SPRINGS LOFTS

RFI#: 37 Date: 1/23/2012 Job: EB-02 Keller Springs Lofts Phone: 877-777-5115

Date Required: 1/25/2012 Request: On sheet P-3.0C the main sanitary trunk line is shown running in the center of the corridors. It is 6" running north along the east side of the garage. It joins another 6" running east along the north side of the garage. So we have a 6" joining with another 6" but there is no designation as to the size of the line after that until it meets the 10" that leaves the building. Sheet P-3.0E gives no designation to the size of this line either. I feel this may be an oversight and the intention would be to have the large to an 8" after the (2) 6" lines merge. Please advice and respond as we are going to be installing these lines in the next two days.

Subject: Pool and fountain equipment drain requirements

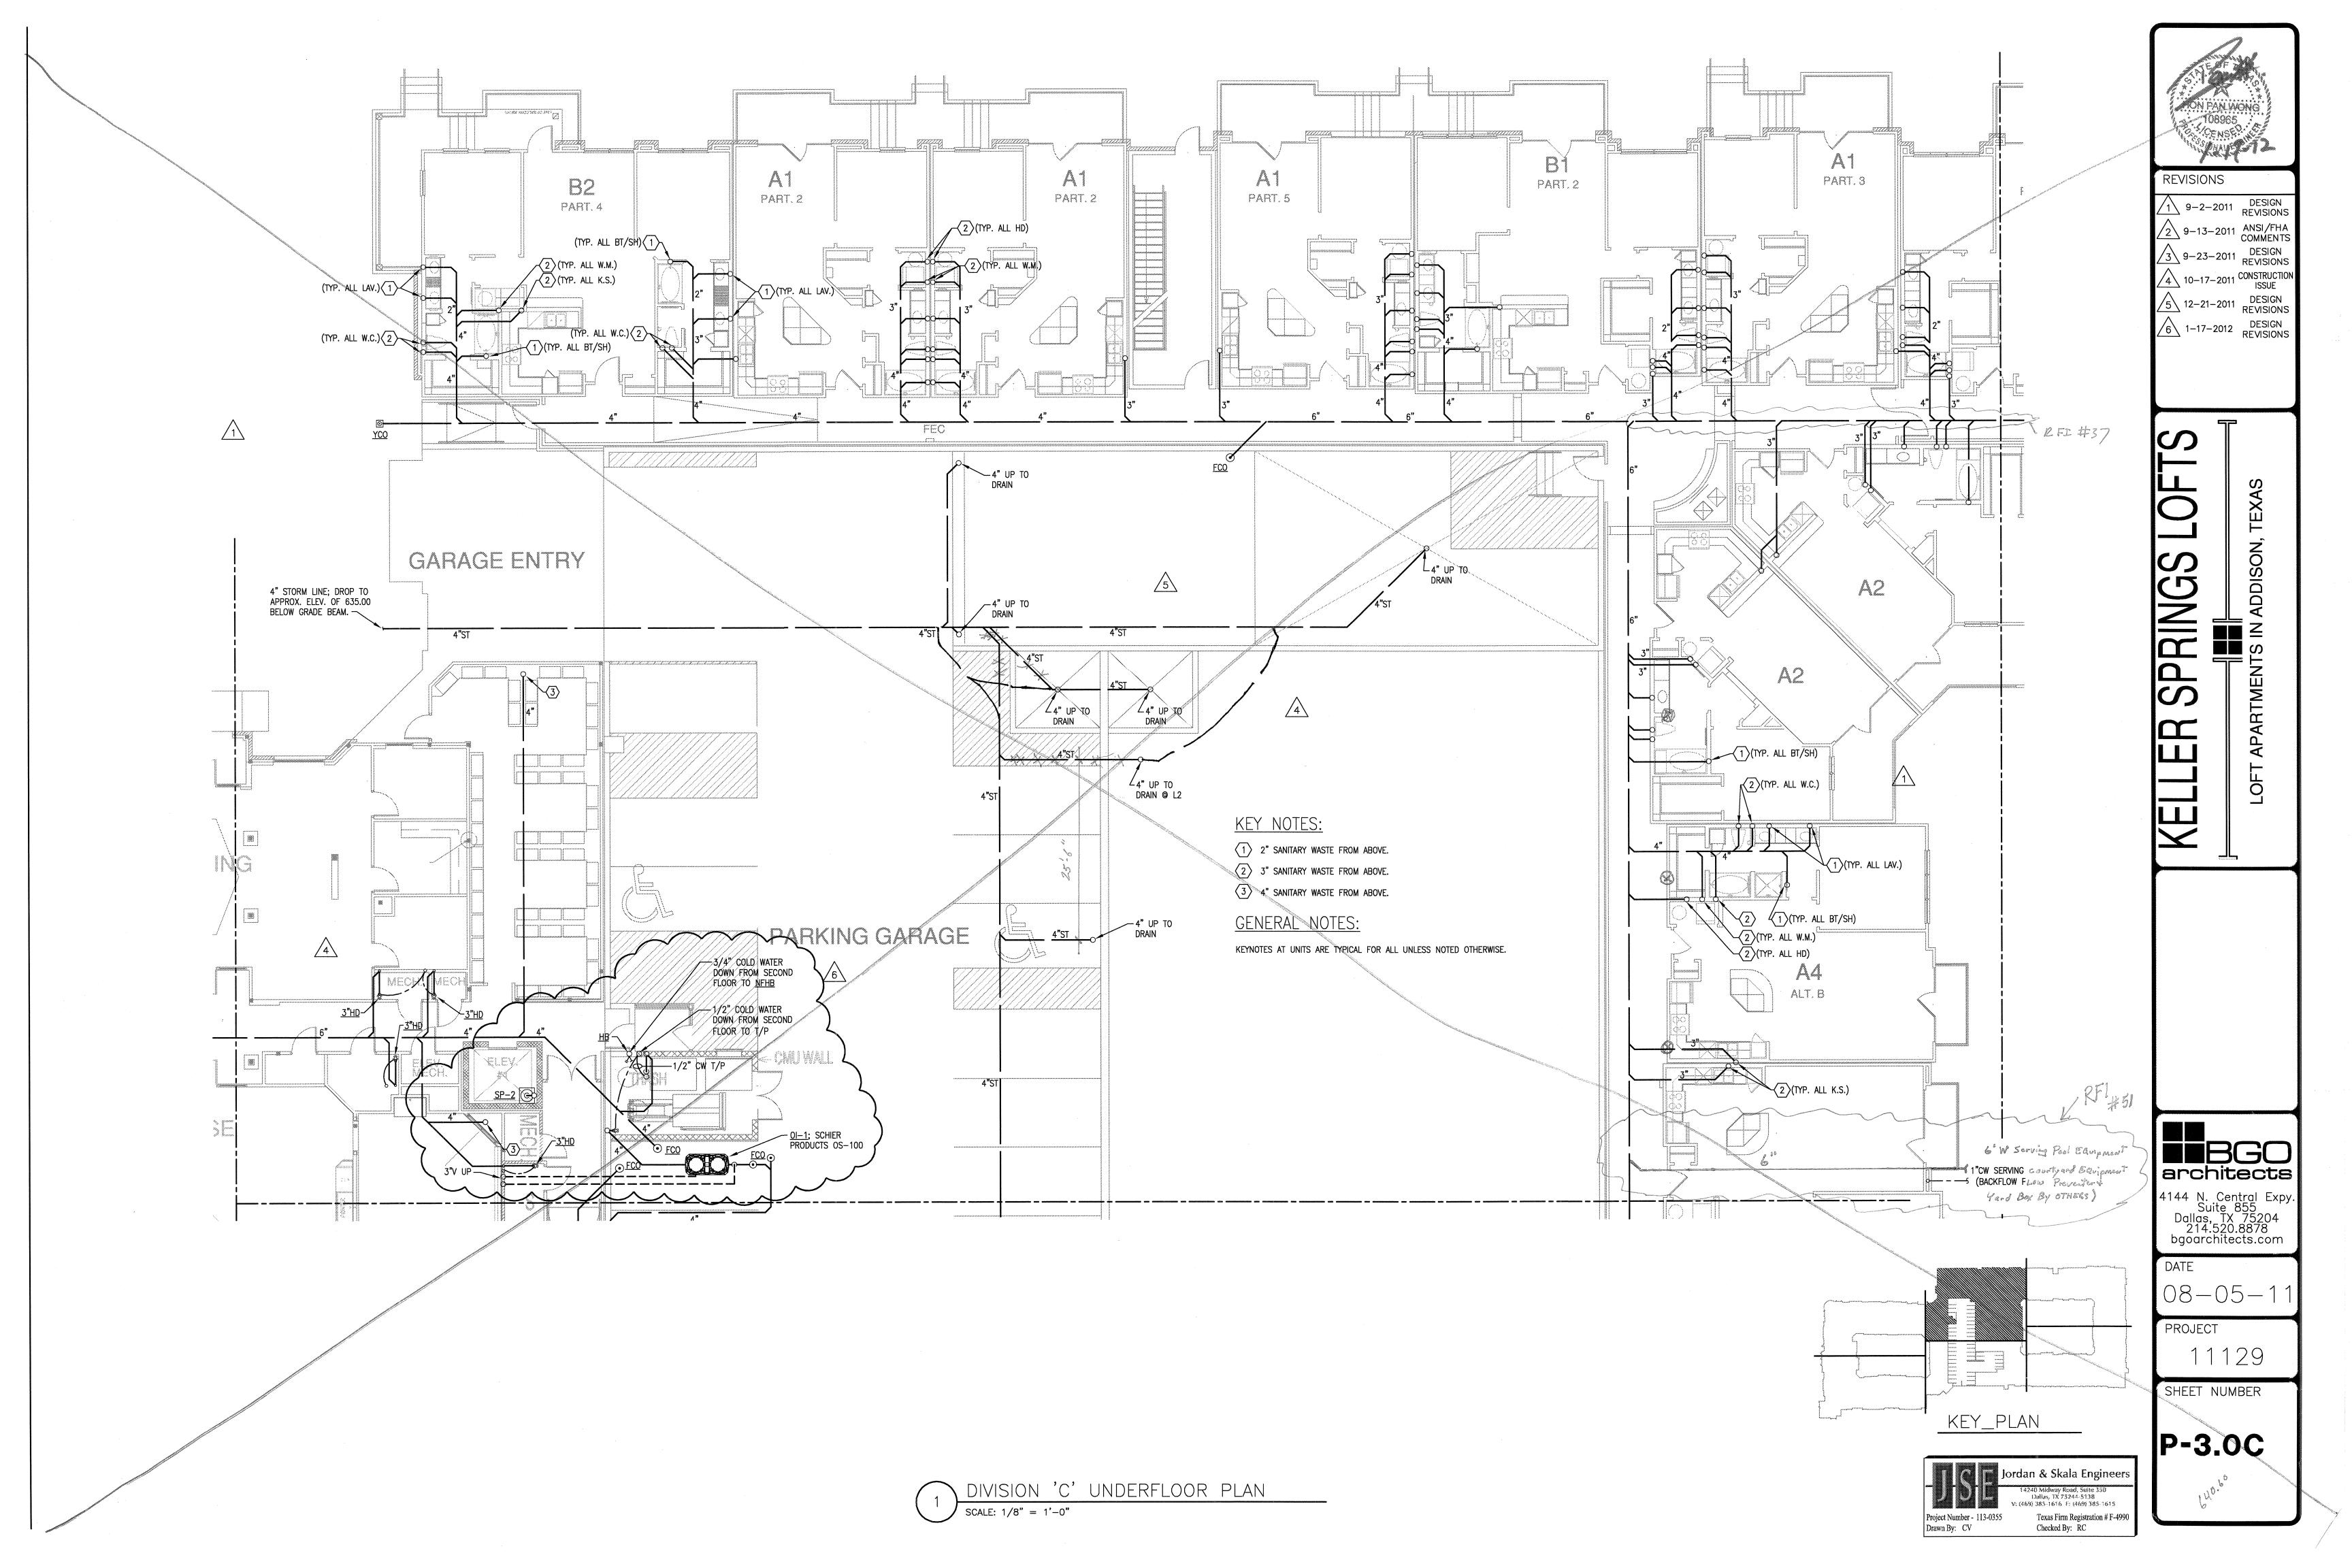
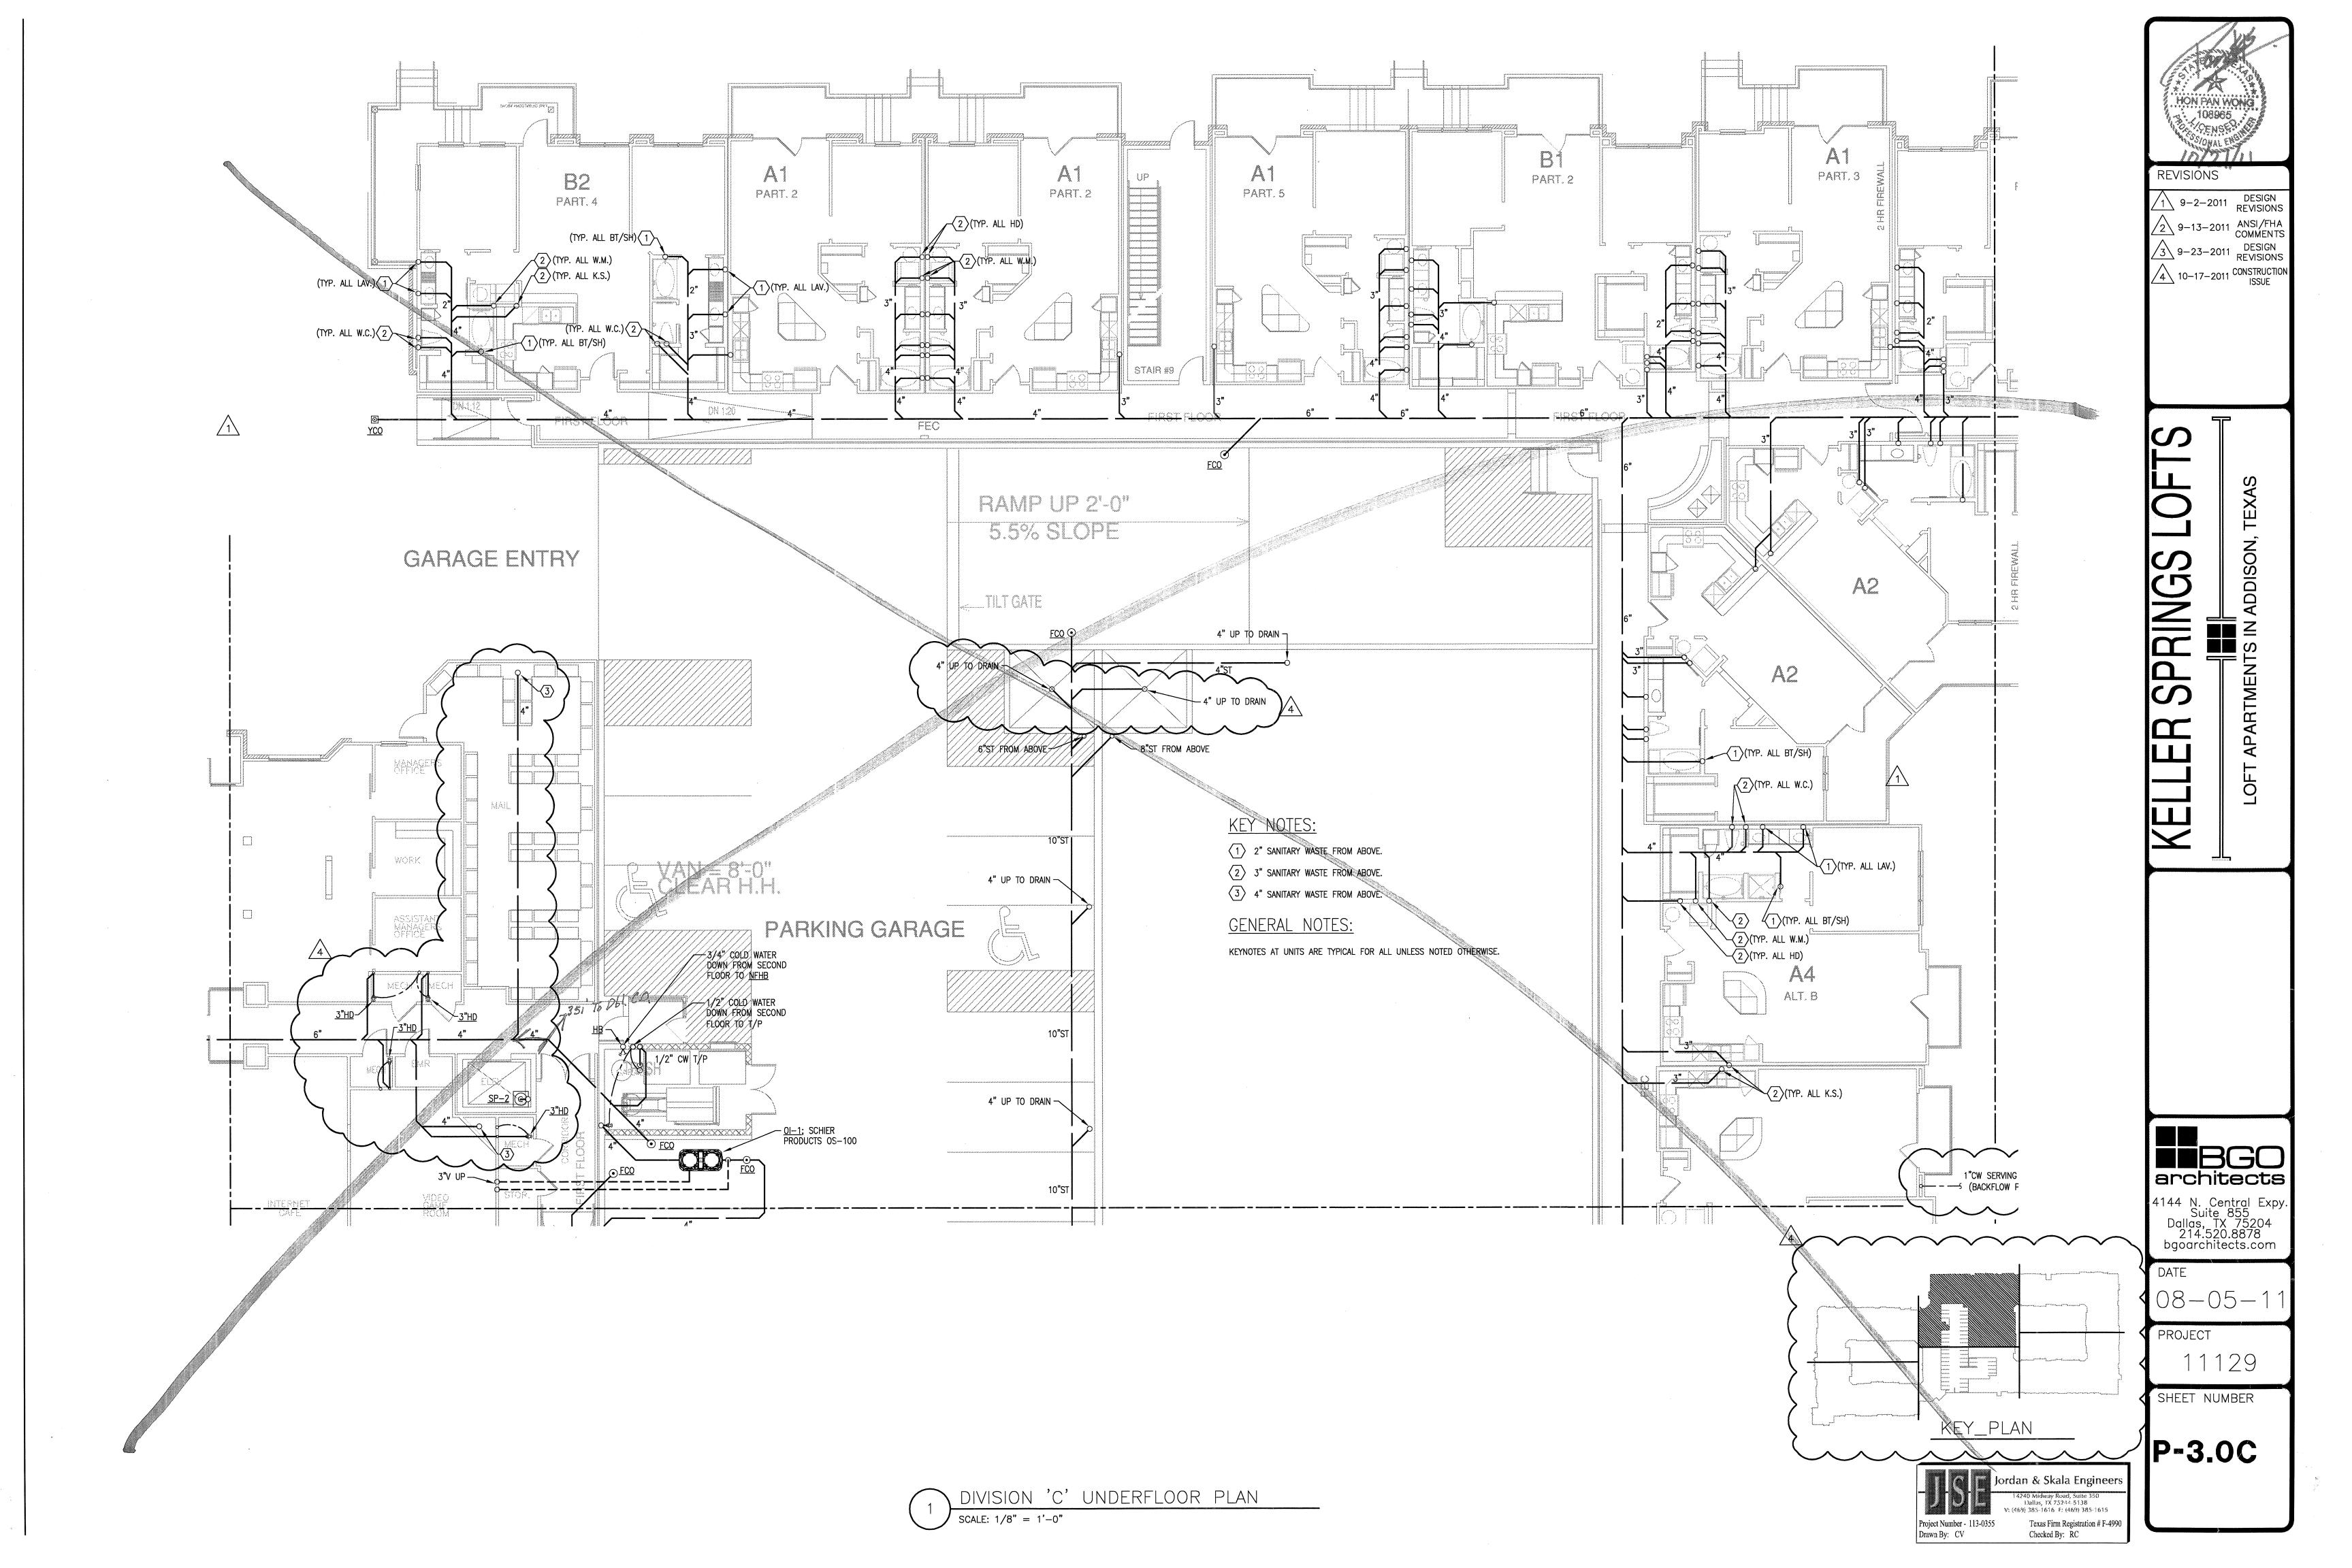
Date Required: 2/14/2012 Request: Jordan and Skala, In discussing the courtyards fountain and pool equipment requirements with our pool contractor, it has come to our attention that since the pool equipment will have a chlorinated filter system, by code, we are required to run that into the sanitary sewer. The fact that the fountain equipment is run with a non-chlorinated system, the pool contractor believes that the fountain equipment can be run into the existing storm sewer system in the fountain courtyard. Therefore we need Jordan and Skala to revise the plans accordingly.

Please reference landscape sheet 5C of 9 for pool equipment location. Requested by: Bryan Pickler Embrey Partners, Ltd.

A 6" sanitary waste line has been routed to pool equipment area for pool drainage. See attached sketch. Russell Cox Answered by 2-16-2012 Date Company
